Rook I Project

Environmental Impact Statement

**Annex 1 Responses:
Federal Indigenous Review Team Information
Request – Round 2**

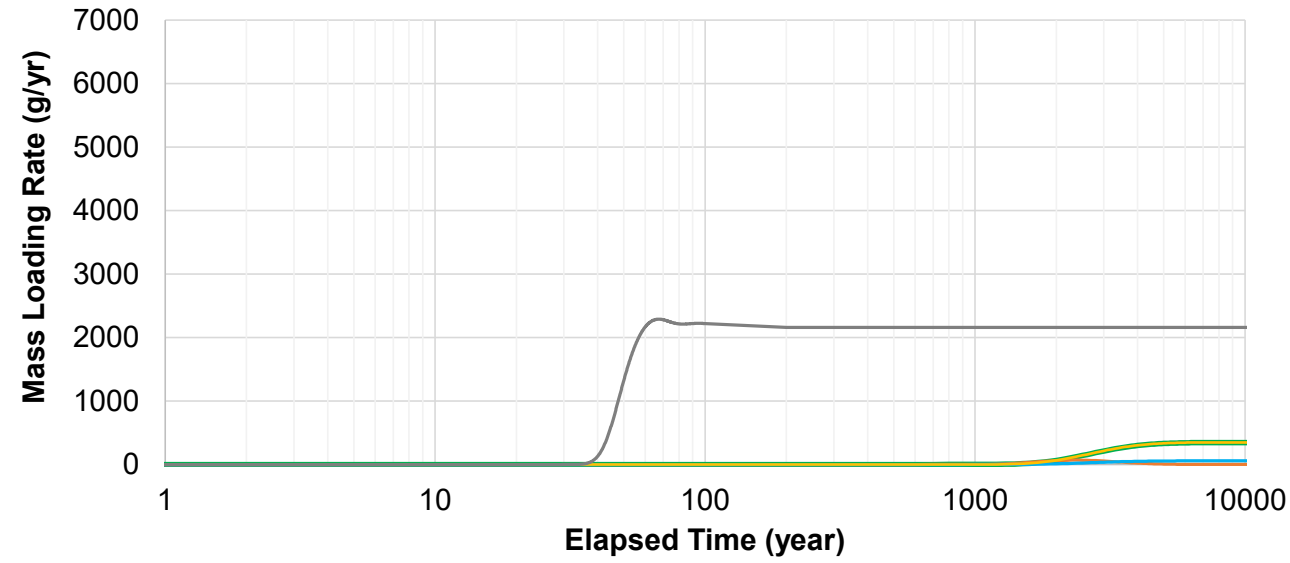
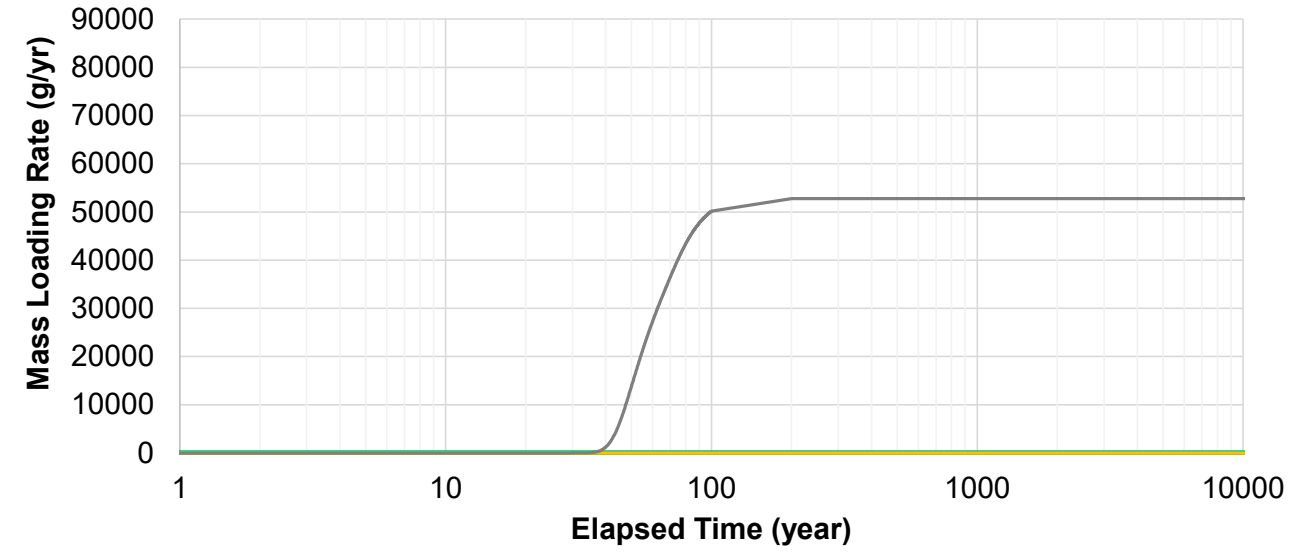
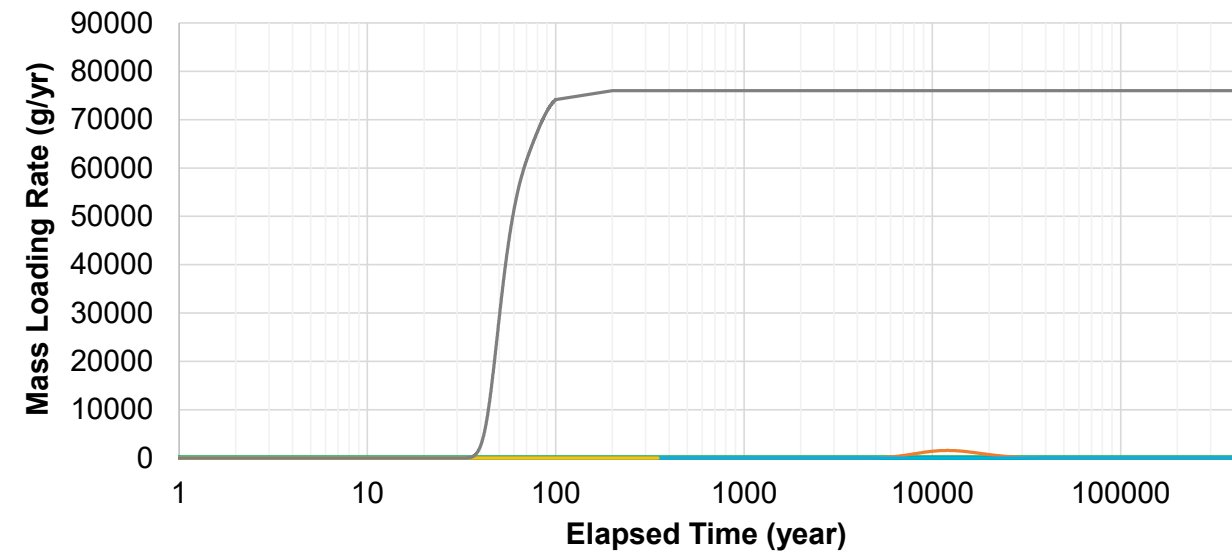
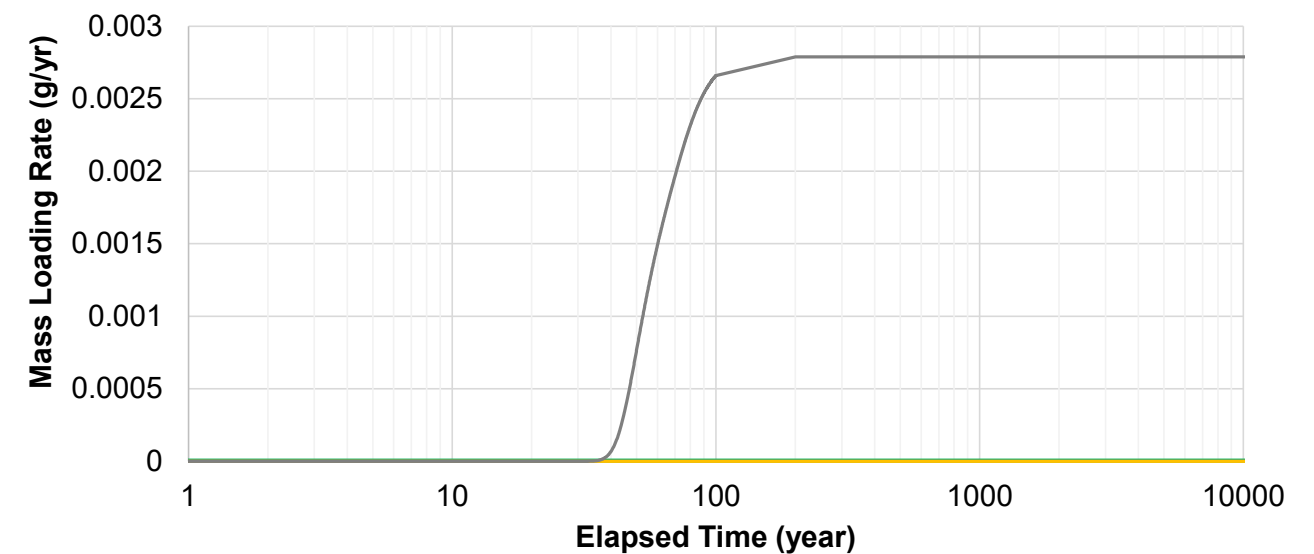
Part 1 - Provide details on how the advective flux of 0.55 m³/d from the UGTMF and 2.7 m³/d from the RMW to Patterson Lake were determined (Figure A-17 of Appendix A of Draft EIS TSD XIV). Details related to how mass flux from the UGTMF to Patterson Lake will occur over time should be provided. The requested details should be included within the body of text in Appendix A, with a summary of key parameters and results provided in the body of the EIS.

NexGen confirms that the advective fluxes presented schematically in Figure A-17 of Draft EIS TSD XIV (Groundwater Flow and Solute Transport Modelling Report) are the predicted fluxes from the groundwater model following reflooding of the underground. The underground was sub-divided into four areas (i.e., underground tailings management facility [UGTMF], primary backfill, secondary backfill, and reflooded mine workings) and a local water budget was completed for each of those regions to extract the predicted flow for each zone.

Figure A-21 of TSD XIV presents a summary of the predicted mass loading rates over time to Patterson Lake from the combined sources presented in Figure A-17 (i.e., UGTMF, primary backfill, secondary backfill, reflooded mine workings, background groundwater, and surface waste). Figure 1 of this attachment presents the requested mass flux over time for the UGTMF to Patterson Lake, as well as for the reflooded mine workings, primary backfill, and surface waste rock for arsenic, copper, uranium, and radium.

To provide the details requested by the reviewer regarding mass flux, Figure 1 of this attachment will be included as Figure A-21b of Appendix A of revised EIS TSD XIV (note: as a result of this edit, Figure A21 of Draft EIS TSD XIV will become Figure A-21a of revised EIS TSD XIV), and the first sentence in Section 4.5 of revised EIS TSD XIV will be modified as follows to reference the new figure: “The simulated peak solute mass loading rates are provided in Table 4, along with the scenarios described in Section 4, Results, and plotted for selected solutes in Figure A-21a and Figure A-21b”.

Given the number of data points representing the predicted mass flux over time up to 400,000 years, the requested mass flux of contaminants from the UGTMF and reflooded mine workings have been presented graphically in Figure 1 for select parameters rather than in a table (selected parameters are consistent with those presented in Figure A-21 of Draft EIS TSD XIV). Table 4 of Draft EIS TSD XIV presents a summary of combined peak mass loading rates for each solute. Figure 1 of this attachment will be included as Figure A-21b of Appendix A of revised EIS TSD XIV, and the first sentence in Section 4.5 of revised EIS TSD XIV will be modified as follows to reference the new figure: "The simulated peak solute mass loading rates are provided in Table 4, along with the scenarios described in Section 4, Results, and plotted for selected solutes in Figure A-21a and Figure A-

Figure 1: Mean Annual Temperature Ensemble Comparison for the 2050s

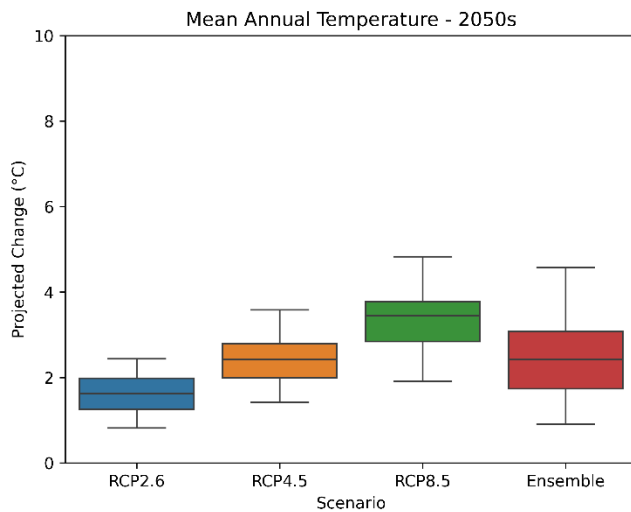
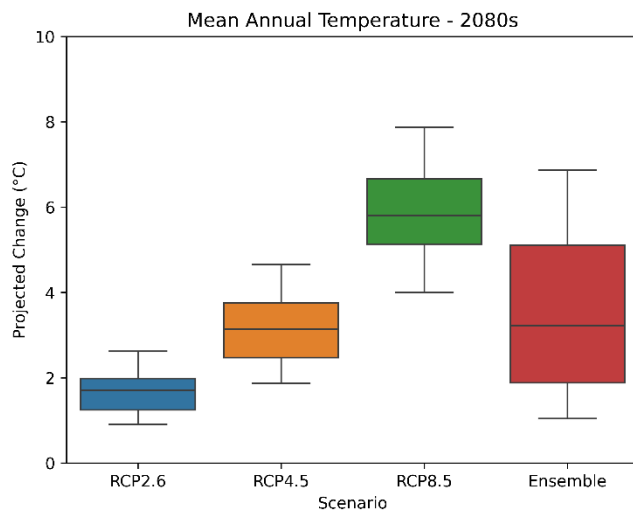
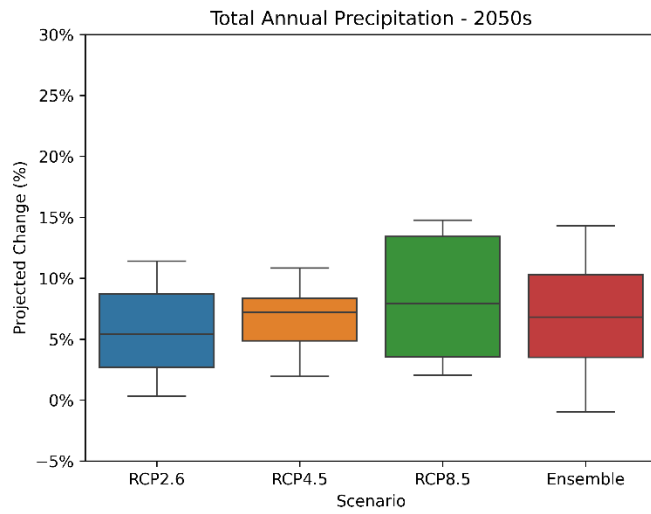
Attachment IR 199-R1 has been developed to resolve the question raised in IR 199-R1 and includes figures (i.e., Figure 1 to Figure 4) that provide a visual comparison of the ensemble projects and individual representative concentration pathway (RCP) scenarios for mean annual temperature and annual total precipitation for the 2050s and 2080s. In addition, text is provided below to explain how the three RCPs were treated and evaluated as part of the multi-model ensemble.

To illustrate how the individual RCPs compare to the multi-model ensemble, the following box and whisker plots present the 5th, 25th, 50th, 75th and 95th percentiles for the model projections from the individual RCPs as well as the ensemble. In addition to the percentiles, the maximum and minimum of the ensemble were also provided in Draft EIS Appendix 22A to capture the full range of projections. As outlined in Draft EIS Appendix 6A (Climate Change Road Map), each discipline incorporated climate projections into their studies according to their impact assessment methods and requirements. In addition, as outlined in Draft EIS Section 22 (Assessment of Effects of the Environment on the Project), Project design will consider how climate may impact design criteria throughout the Project lifespan.
